Work Order ID 164168

Item Name: Heli-Access-Step™ RH - Low Gear, Short Step, Aerazur Float Compatible

DART SERVICE INSTRUCTION

TO AMEND INSTALLATION INSTRUCTIONS D350-591 REV. G OR EARLIER
AND
INSTRUCTIONS OF CONTINUED AIRWORTHINESS ICA-D350-591 REV. 2 OR EARLIER
REF CANADIAN STC: SH92-6
REF FAA STC: SH967NE

FIGURE 1: CLAMP DETAIL
OPTIONAL CLAMP CONFIGURATION

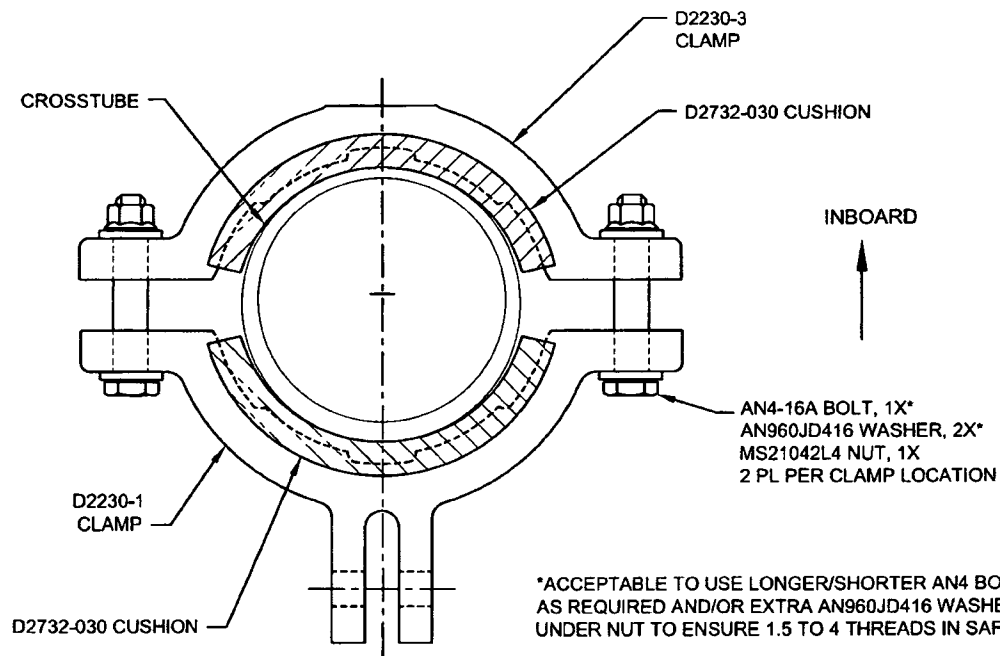
For D350-591-213/-214/-215/-216 steps, customers have the option of installing D2732-030 cushion under the clamps to accommodate varying crosstube diameters and to improve fit, as indicted in Installation Instructions D350-591. This Service Instruction adds longer AN4-16A bolts to the parts list to allow installation of these cushions. See Figure 1 on sheet 2 of this service instruction for reference. Installation of the D2856-400-720 Abrasion Strips per Installation Instructions D350-591 is not required when the cushions are installed.

For D350-591-213/-214/-215/-216 steps at CHG 003, the parts list of D350-591 Rev. G and ICA-D350-591 Rev. 2 is amended as follows:

Qty -213	Qty -214	Qty -215	Qty -216	Part Number	Description
X				D350-591-213	<i>Heli-Access-Step</i> ™, Short Step – High Skid, LH
	X			D350-591-214	<i>Heli-Access-Step</i> ™, Short Step – High Skid, RH
		X		D350-591-215	<i>Heli-Access-Step</i> ™, Short Step – Low Skid, LH
			X	D350-591-216	<i>Heli-Access-Step</i> ™, Short Step – Low Skid, RH
4	4	4	4	AN4-16A	BOLT
